**Flood Control Project Maintenance
Levee Inspections**
LMA District Cover Sheet
Spring 2018 Levee Inspection Results

Plumas County

Levee Inspection Report By Mile - Spring 2018

Waterway	Bank	Unit Miles	Inspection Start/End	Inspector
Unit No. 01 North Fork Feather River	Left	1.89	04/26/2018 04/26/2018	Bob Duffey

Photo 1 of 1 : SP_2018_NA0015_337_18_20180501_00027.jpg

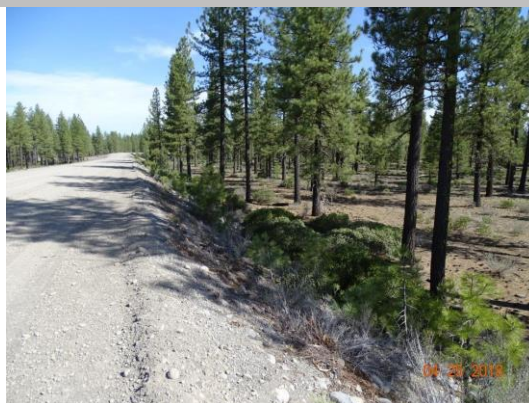
LM Start	0.79	Rating **	M	Issue No.	18
LM End	1.88	Issue Type +	Ma	Location *	LS
Category	Earthen Levee			GPS Latitude/Longitude	
				Start	End
Item	Vegetation			40.282962 °	40.297068 °
				-121.251307 °	-121.257120 °
DWR ID	DWR_NA0015_01_s_2018_18				
Comment Code					
V2 : Remove the wild growth other than native grasses from the levee slopes.					
Inspector Comment					
Remove the small pine trees and vegetation from the landside slope.

View of the small pine trees and vegetation along the landside slope.
